# SERVICE BULLETIN REVISION TRANSMITTAL SHEET

MODEL BD-100-1A10 (CL-300)

Service Bulletin No. 100-32-25

## SPECIAL CHECK/MODIFICATION - NOSEWHEEL-STEERING CONTROL SYSTEM - REPLACEMENT OF THE STEERING MANIFOLD

Steering Manifold – Special Check  
Figure 1

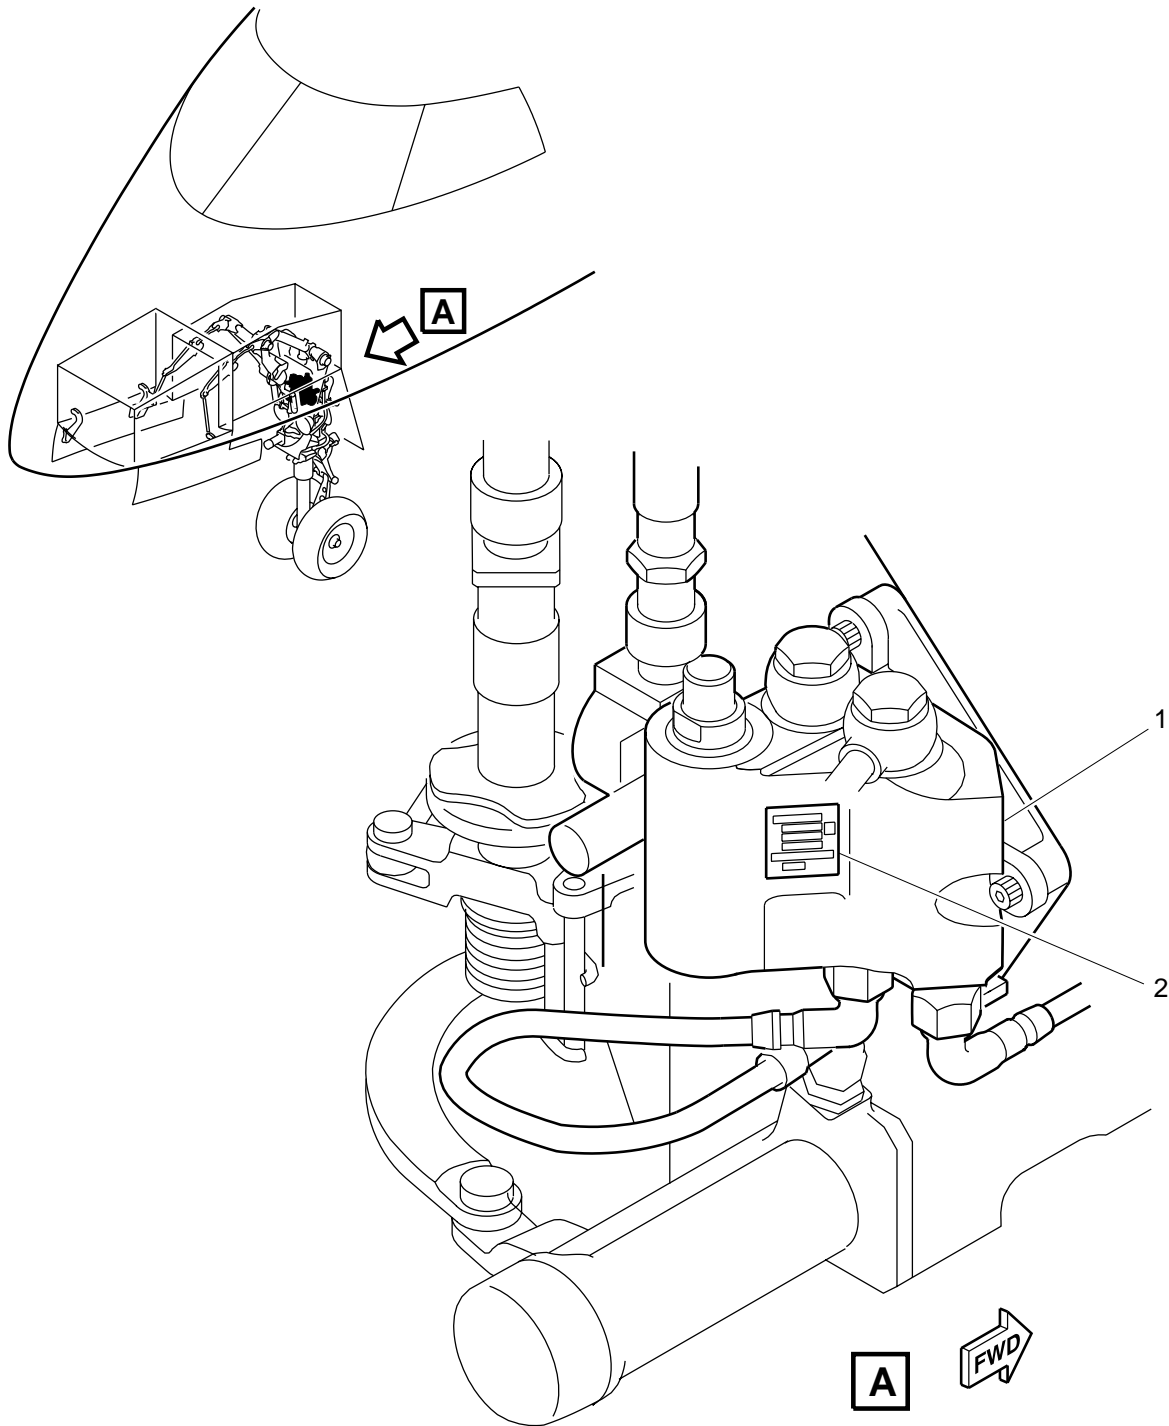
- (1) Verify the Part No. of the steering manifold (1) on the identification plate (2). Refer to Figure 1.
- (2) For aircraft with a steering manifold Part No. 40750-103, continue to Paragraph 2.D.
- (3) For aircraft with a steering manifold, Part No 40750-101, continue with PART B of this Service Bulletin.
